### Record of Executive Business and Chief Executive's Order

**Reg. Reference:** SDZ23A/0004 **Application Date:** 10-Feb-2023

**Proposed Development:** 385 dwelling units (139 houses, 70 Build-to-Rent

**Location:** In the townland of Adamstown, Lucan, Co. Dublin

Figure 2 – Movement Concept in Planning Scheme

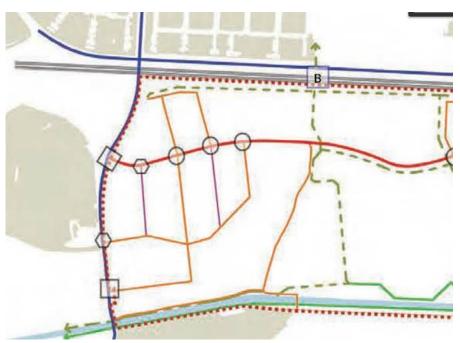
The application has not proposed amendments to the street approved under SDZ20A/0021. It is noted that the scheme requires three local streets to the north of the link street and the applicant has provided these. To the south of the link street, two intimate local and two local streets are required. The applicant has provided an additional local street which is acceptable as it is not a fixed building line. There is also a requirement for a local street running along the southern boundary of the applicants site, ending in a non-vehicular junction with the Newcastle Road – the applicant has provided this. The scheme also indicates a strategic cycle route to the north of the local street at the north of the site. It is not apparent that this has been included and **additional information** is requested.

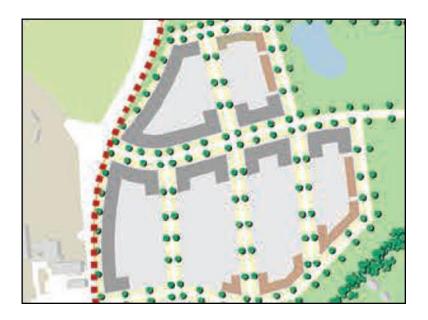
Section 2.2.4 of the Scheme outlines that the centre line and alignment of the Local Streets and Homezones are flexible with the exception of streets with frontages prescribed under Section 3 (Development Areas). In this instance, the application site contains prescribed frontages in the form of Avenue Frontage, Railway Frontage and Park Frontage (Figure 3.1) as per the image below.

The additional local street to the south of the link street is to the rear of the duplex and does not meet the avenue. There are therefore no implications for any of the fixed frontages.
